SIGNAGE SPECIFICATIONS

(A) Face/Halo Lit Channel Letters on Raceway with Contour Backer - QTY: 1

**4301 SOUTH MERIDIAN
 SUITE F3
 PUYALLUP, WA 98373**

SIGN LOCATION

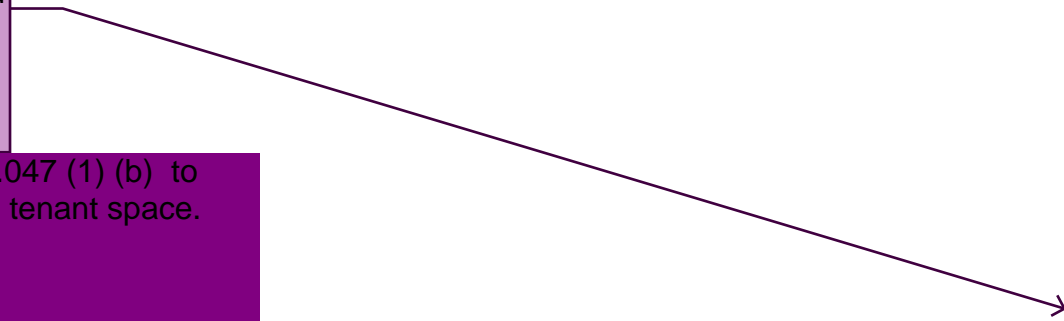
Please show lineal feet of building wall.
 Planning Comment.

SITE PLAN

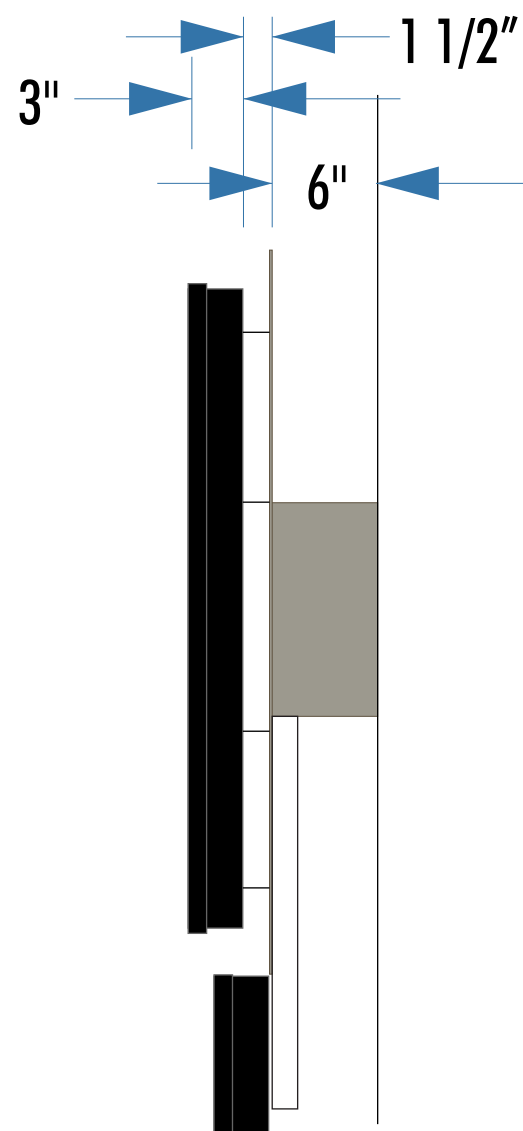
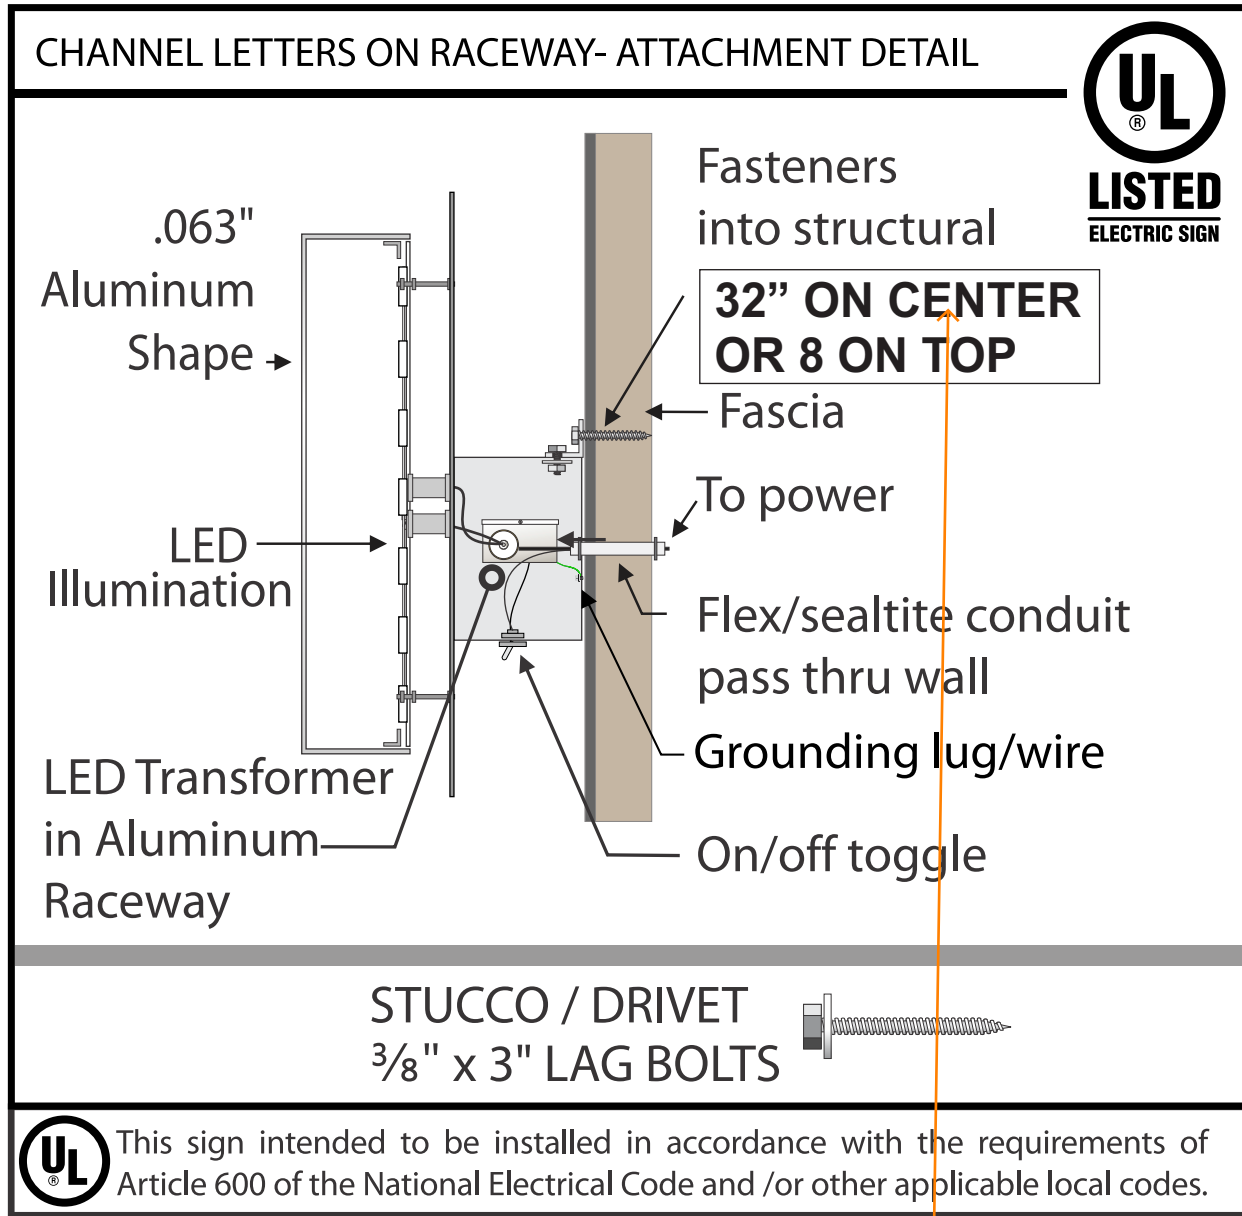
Please show measurement of lineal feet of building wall that the sign will be attached on site plan. Planning Correction

Please see PMC 20.60.047 (1) (b) to measure the size of the tenant space.

Correction, Site Plan, Pg. 2
